Applicant Section 55 Planning Response Report – Sunfield Substantive Application – FTAA-2503-1039

16th October 2025

This Planning Report (**response report**) is prepared on behalf of the applicant, Winton Land Limited, pursuant to section 55 of the Fast-track Approvals Act 2024 (**FTAA**) responding to the written comments received from invited parties pursuant to section 53 of the FTAA.

Figure 2: Amended Proposed Masterplan (Source: Studio Pacific - Masterplan)

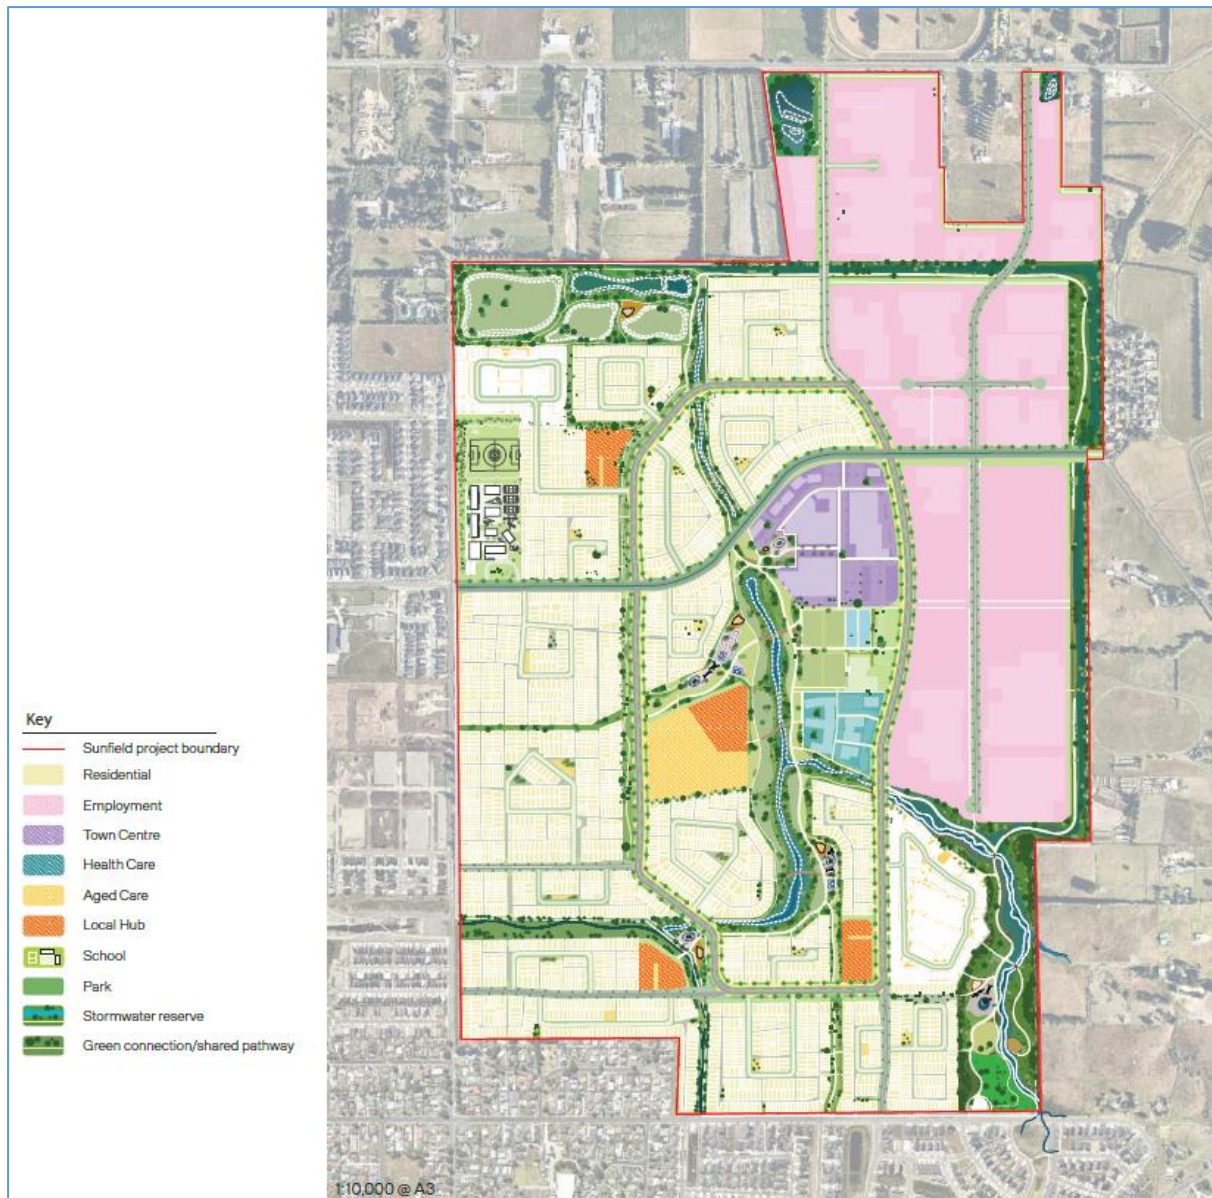
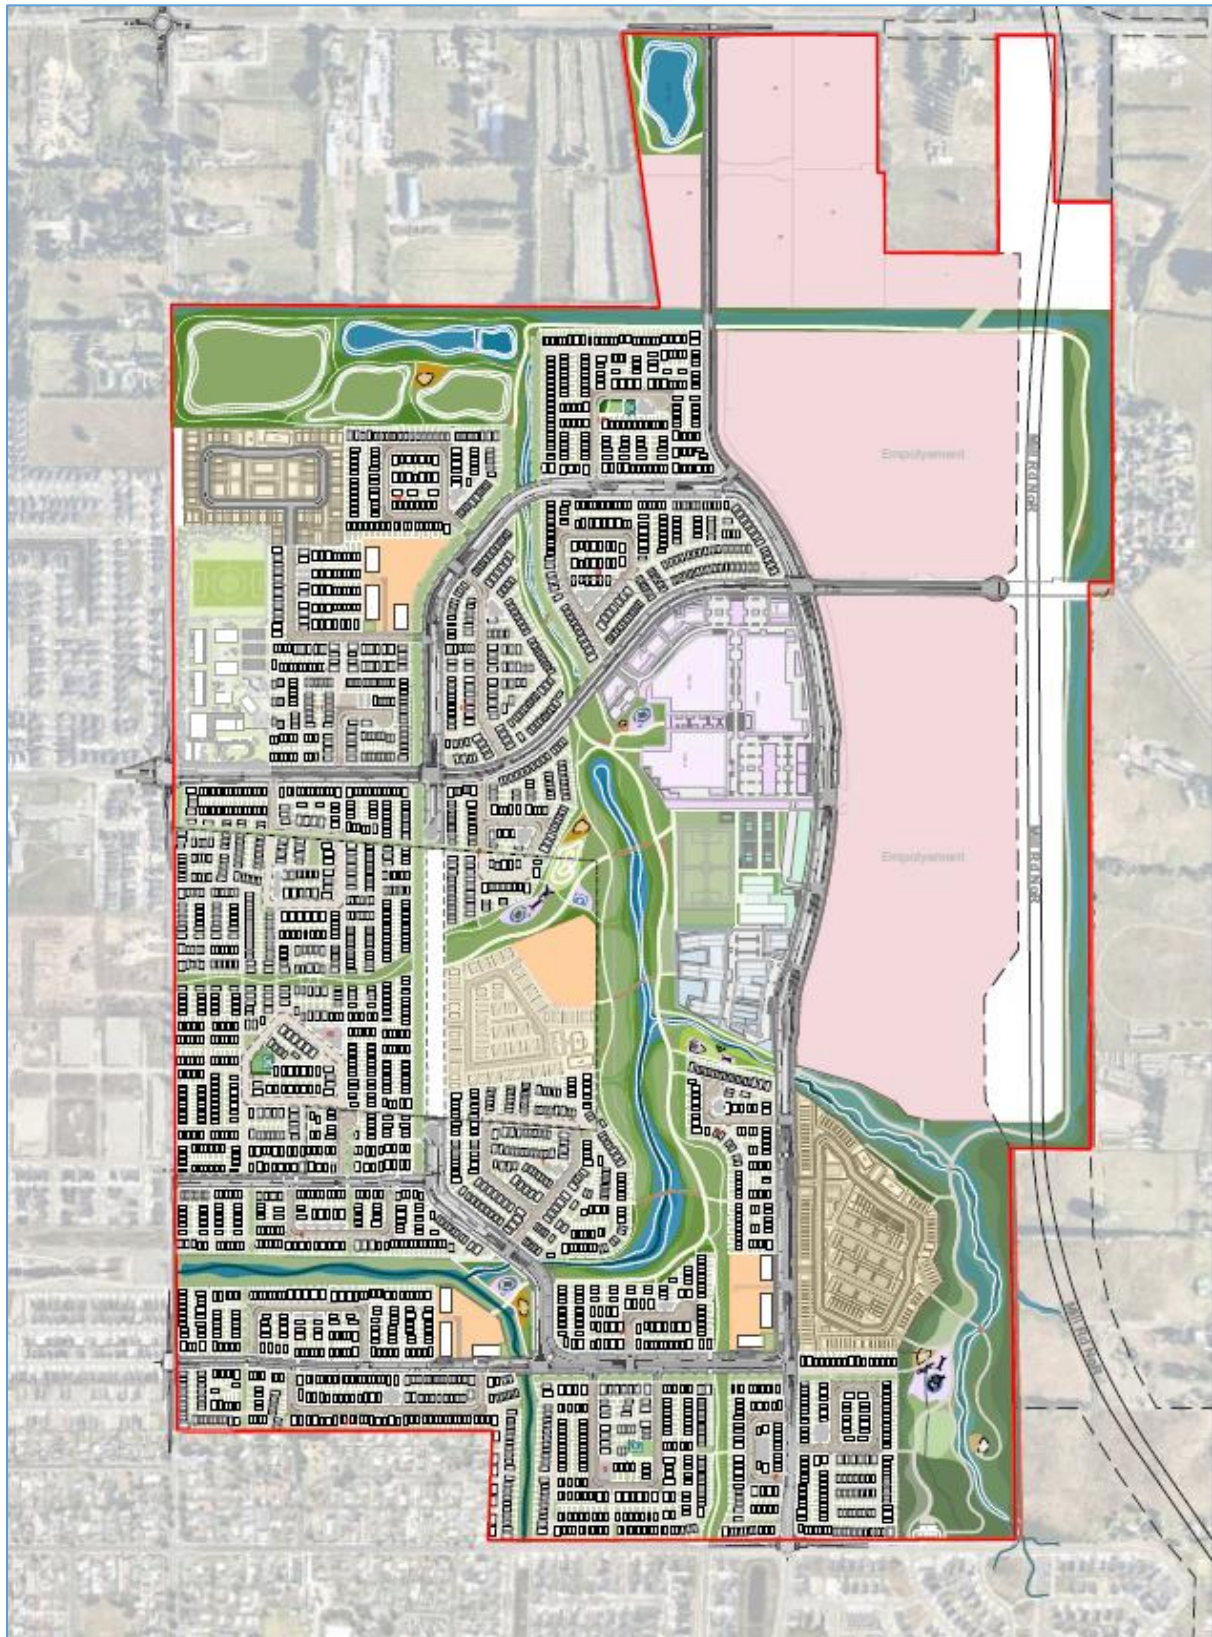
The proposed amendments are highlighted within **Figures 1 and 2** below, with **Figure 1** illustrating the original proposal, and **Figure 2** illustrating the amended proposal. The amended proposal is illustrated in further detail within the updated Masterplan, Precinct Plans and associated Neighbourhood Plans, which are contained within **Attachment C**, along with the updated Engineering Plans, Scheme Plans and Staging Plan contained within **Attachments E and F**. The below provides a written summary.

Figure 10: Town Centre Car-Park (Source: Studio Pacific Architecture)

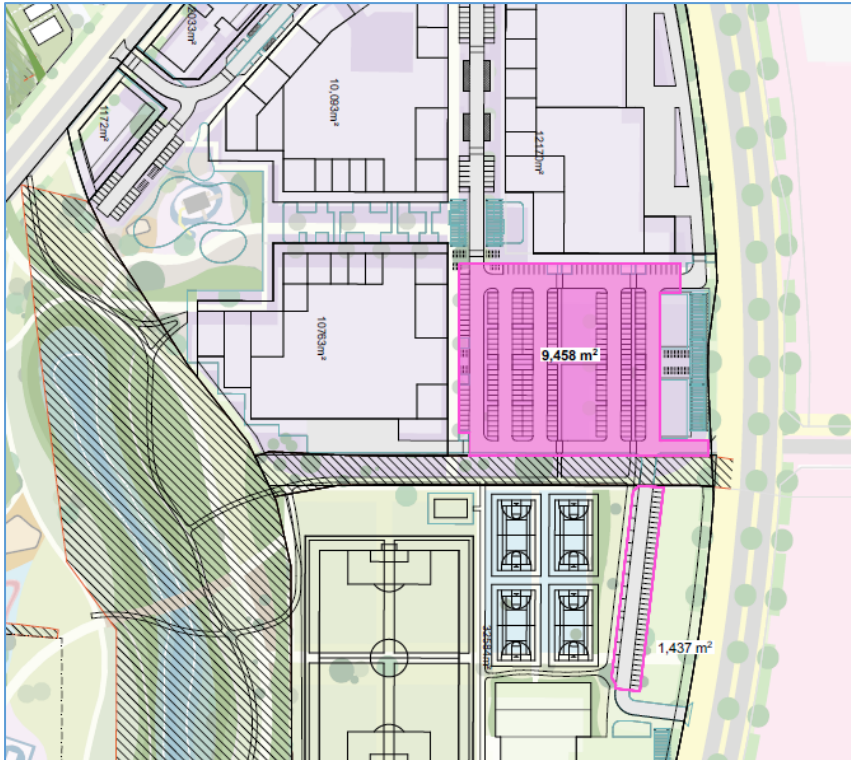
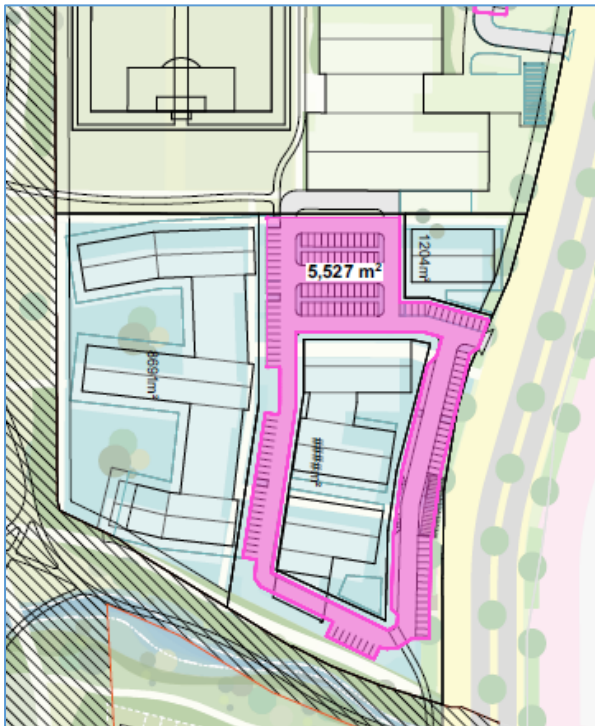
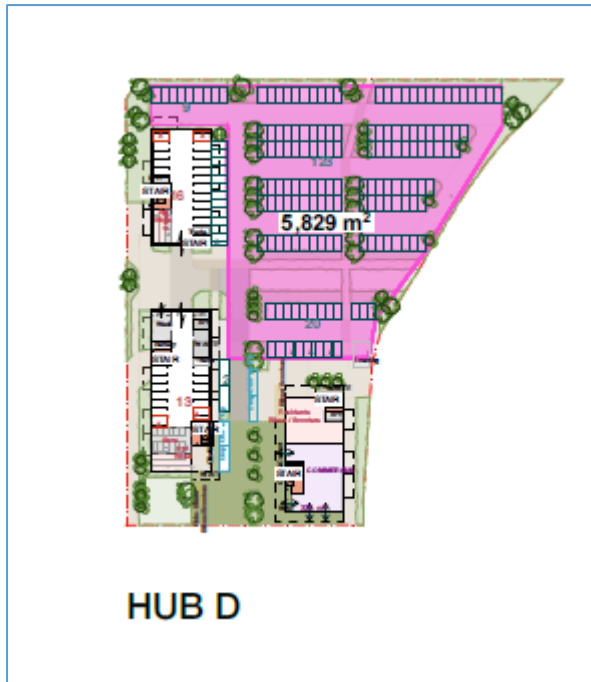
The proposal involves high contaminant generating car-parks which are exposed to rainfall and designed for more than 30 vehicles. There are three car-parks within Sunfield which are greater than 5,000m², which have a collective area of 21,000m². These include the main car-park in the proposed Town Centre (**Figure 10**), the Healthcare facility car-park adjoining the Town Centre (**Figure 11**), and the car-park within Local Hub D in the north-west portion of Sunfield (**Figure 12**).

The proposed roads within Sunfield will not carry more than 5,000 vehicles per day (approximately 3,000 are anticipated), meaning they are not classified as high use roads.

Figure 13: Open Space Flood Depth Plan (Source: Maven)

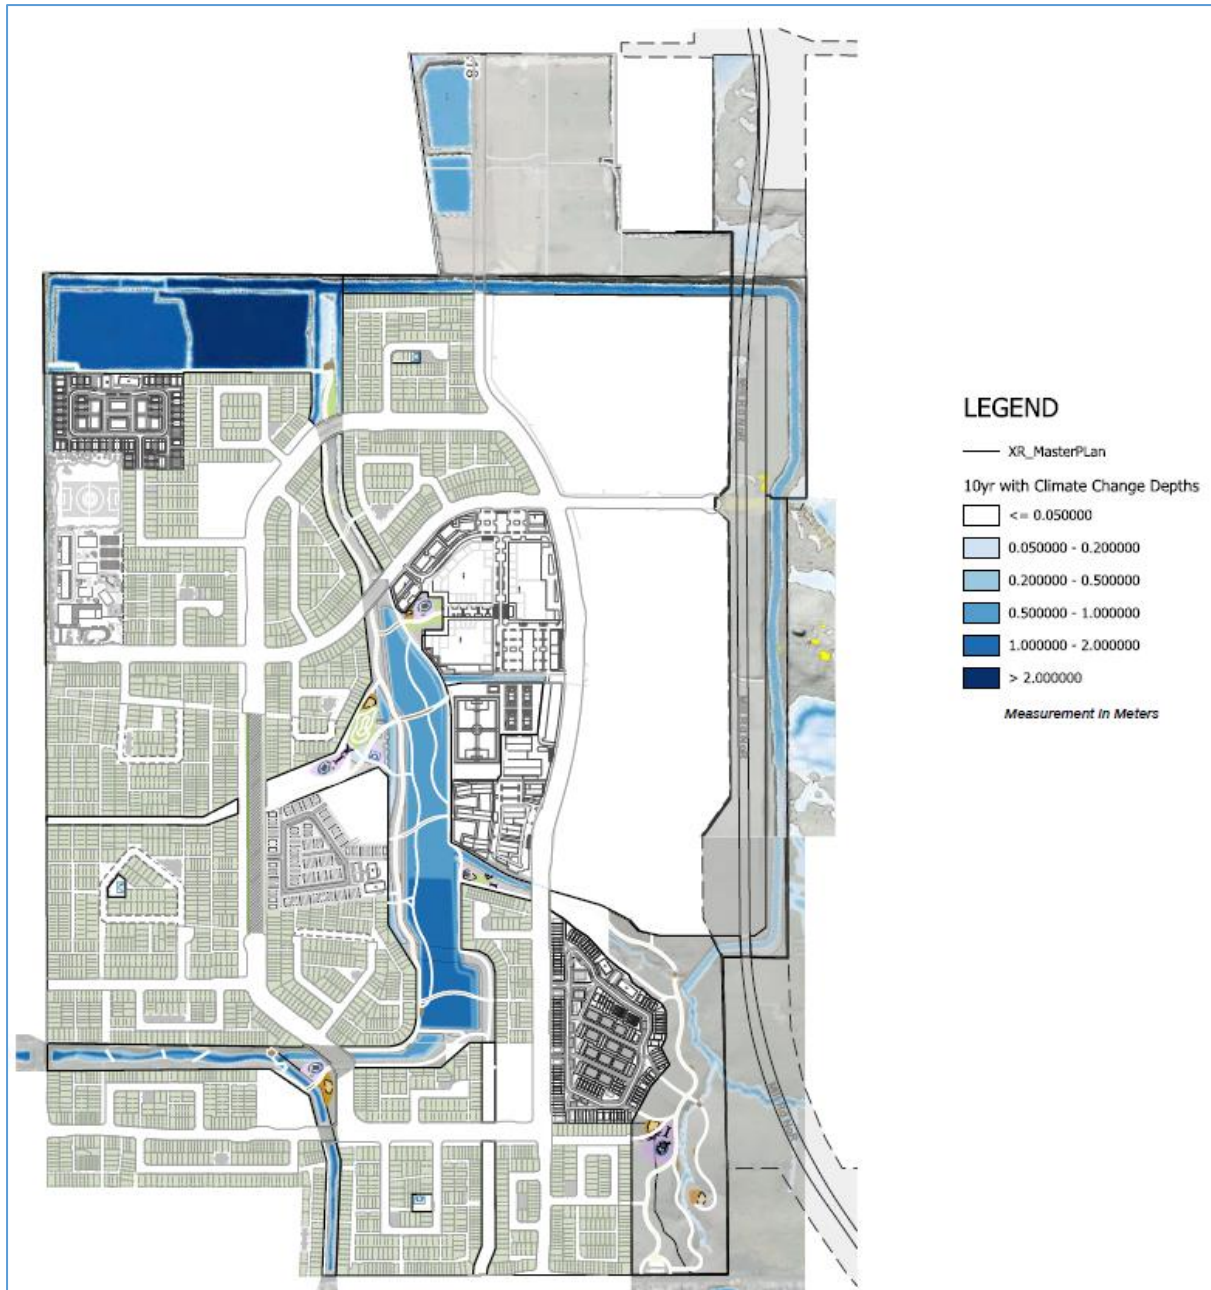
Auckland Council have raised concerns with the location of the proposed formal recreation areas being within flood affected location, and that three additional neighbourhood parks should be provided, each with a minimum size of 2,500m² to 3,000m².

It is considered that stormwater management areas and open space areas can overlap with it being an efficient use of land given the dual purpose, with examples already occurring within Auckland such as Awakeri Wetlands Stage 1, and Greenslade Reserve, Northcote. An Open Space Flood Plan is provided within **Attachment C6** which illustrates the effect on these areas from a 10 year event, and the inundation time for a 2 year and 10 year event (with climate change). This is illustrated in **Figure 13** below.
